# **Final Focused Feasibility Study Report**

## **Ground Water Remediation**

**Shieldalloy Metallurgical Corporation**  
**Newfield, New Jersey**

**April 1993  
Revision 1: June 1993  
Revision 2: February 1994**

FIGURE 1-10.  
APPROXIMATE LOCATION OF VINELAND  
WELL RESTRICTION AREA

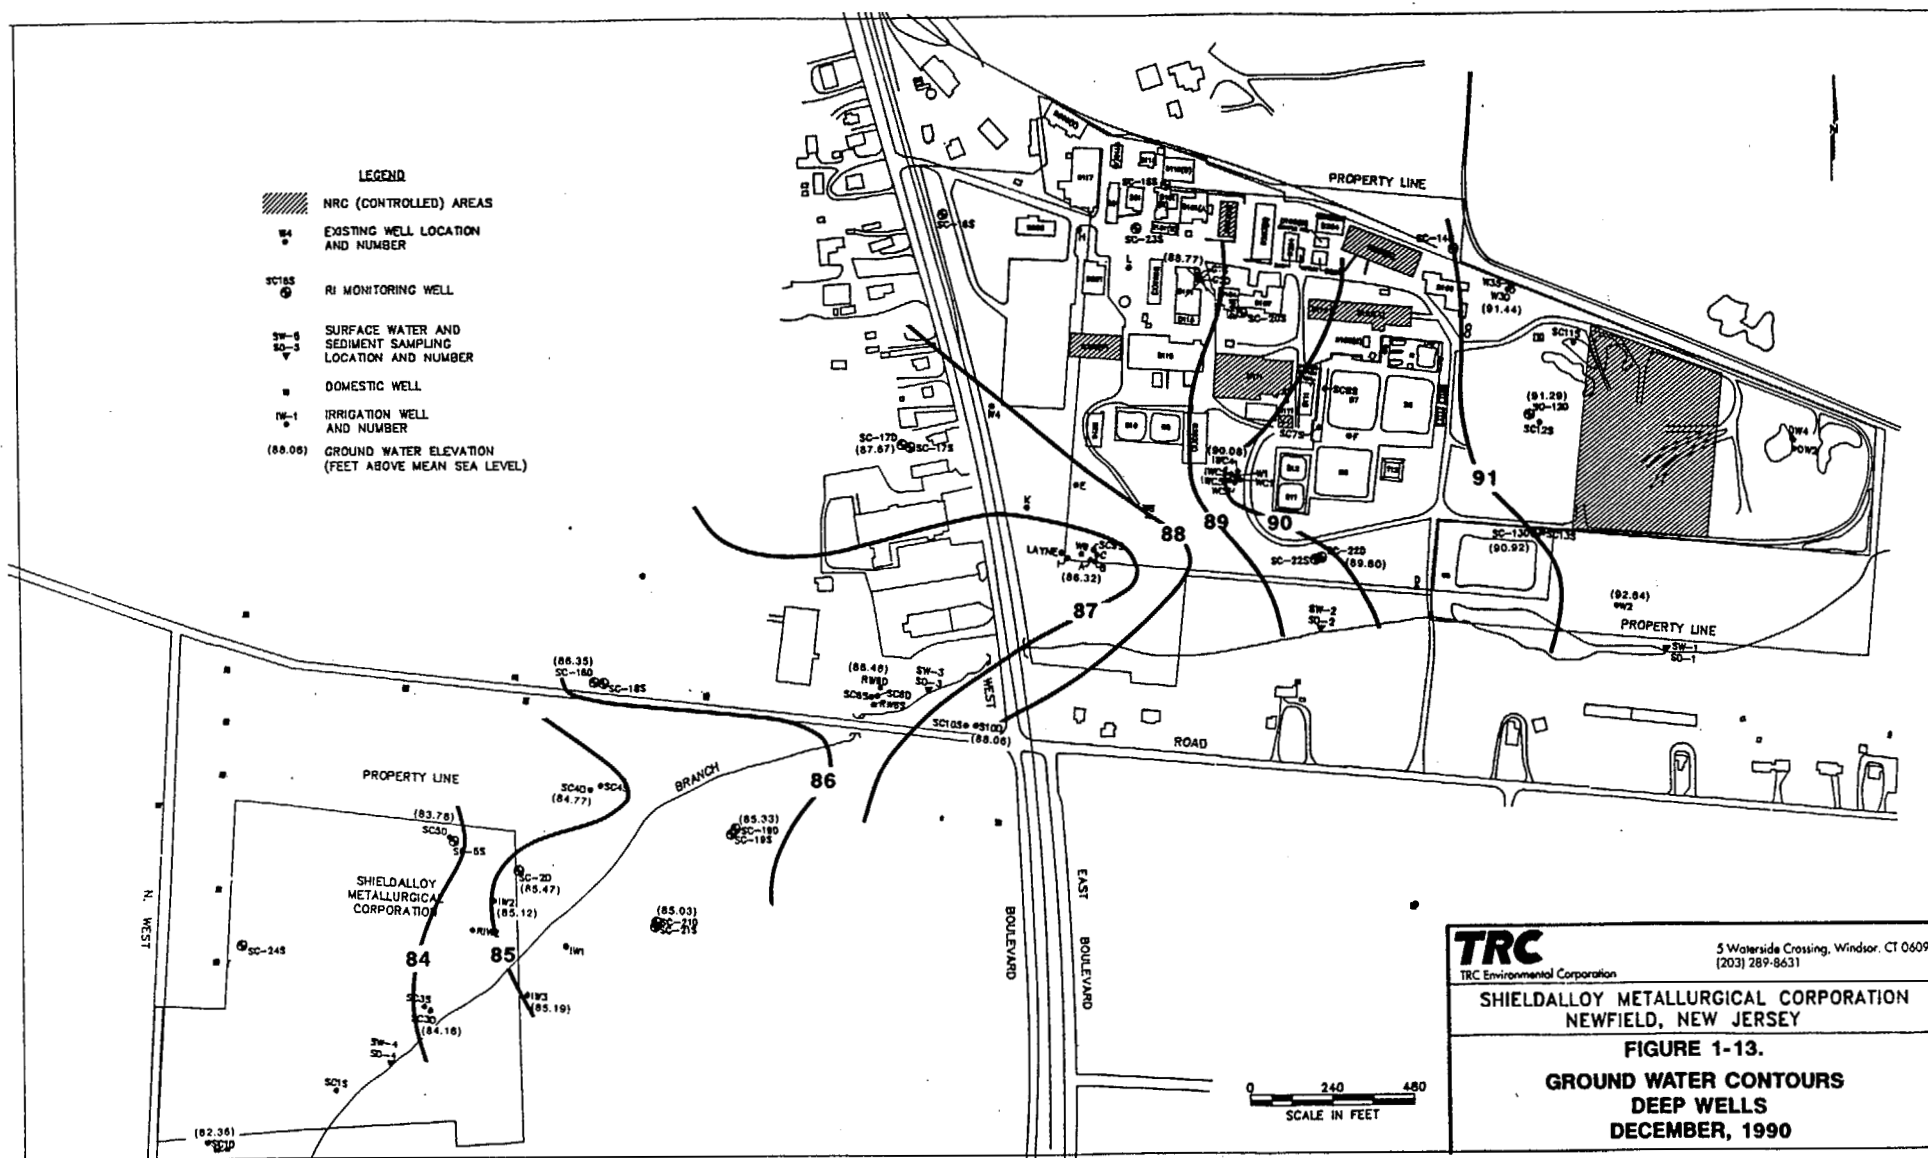
This section describes a 2-acre parcel of SMC-owned property along Weymouth Road in Newfield and shows the location on Figure 5-11. This SMC-owned property shall also be shown of Figures 1-2, 1-3 and 1-4 at a minimum.

Response: *The general location of this parcel is shown on Figure 5-11. However, this parcel has historically been limited to residential use and is not pertinent to the overall RI/FS investigation of the SMC facility. Therefore, its location is not shown on Figures 1-2, 1-3 and 1-4.*

**FIGURE 3-5.**  
**OTHER ORGANICS DETECTED AT**  
**LEVELS EXCEEDING ARARs IN THE**  
**UPPER COHANSEY SAND**

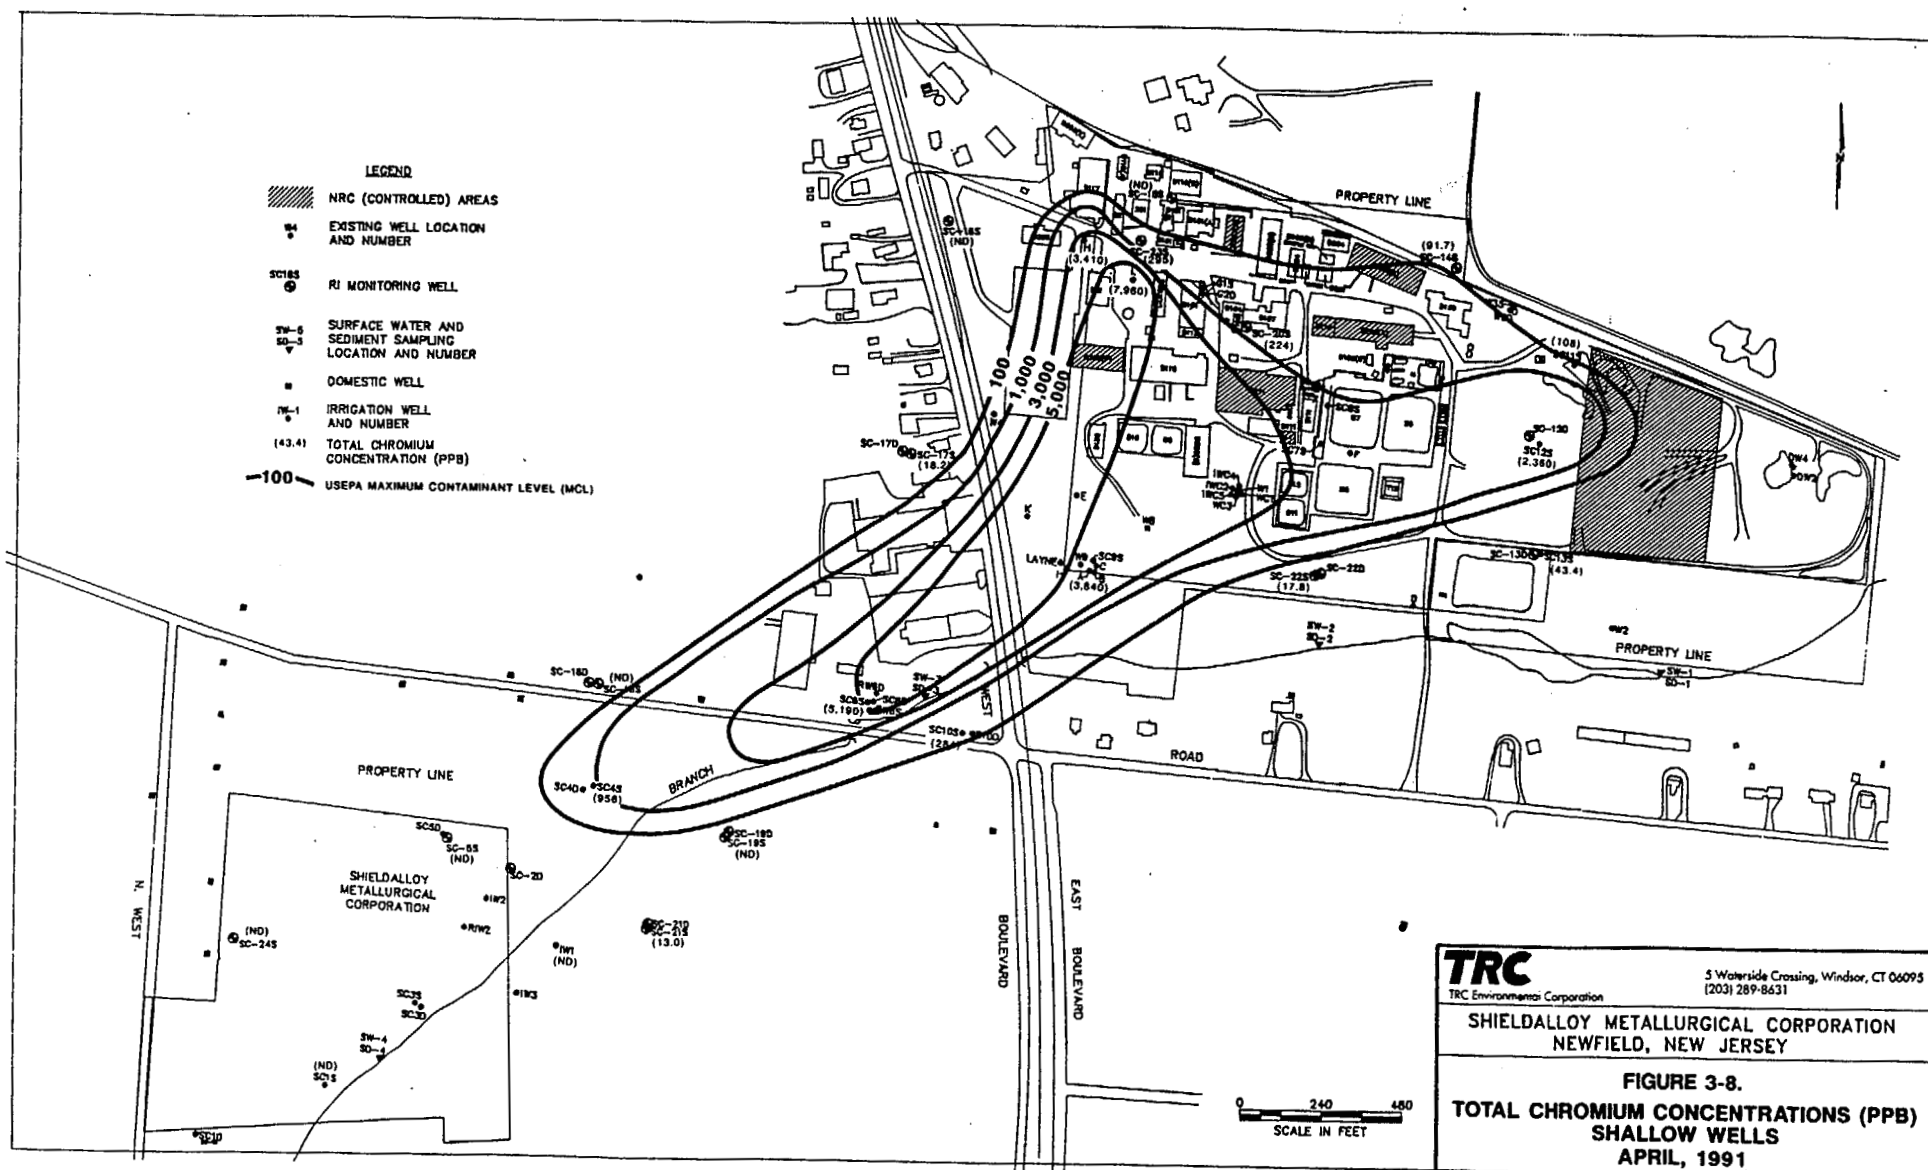
The danger of putting too much emphasis on isopleth maps is that it is difficult to keep in mind that they can only show concentrations where wells have been sampled. For example, the deep TCE contours (Figures 3-4 and 3-5) show a 1 ppb "boundary" on the south side of the plume. Now, with the discovery of 12 ppb TCE in SC22D, it is obvious that the previous boundary was present only because data points were lacking in critical areas.

Response: *An initial review of the TCE isopleth maps may seem to indicate an offset in the deep TCE plume to the south from the shallow plume location, however, this offset may be partially due to the lack of deep ground water data in the plant area (see the response to general comment #20). In December 1990, well G2D, the only deep well in the plant area, exhibited no TCE. Well G2D was not sampled in April 1991. Therefore, while TCE contamination in the deep wells could potentially extend to the northeast of the area shown in Figures 3-3 and 3-4, the lack of data in this area resulted in the interpretation of isopleths as presented in these figures.*
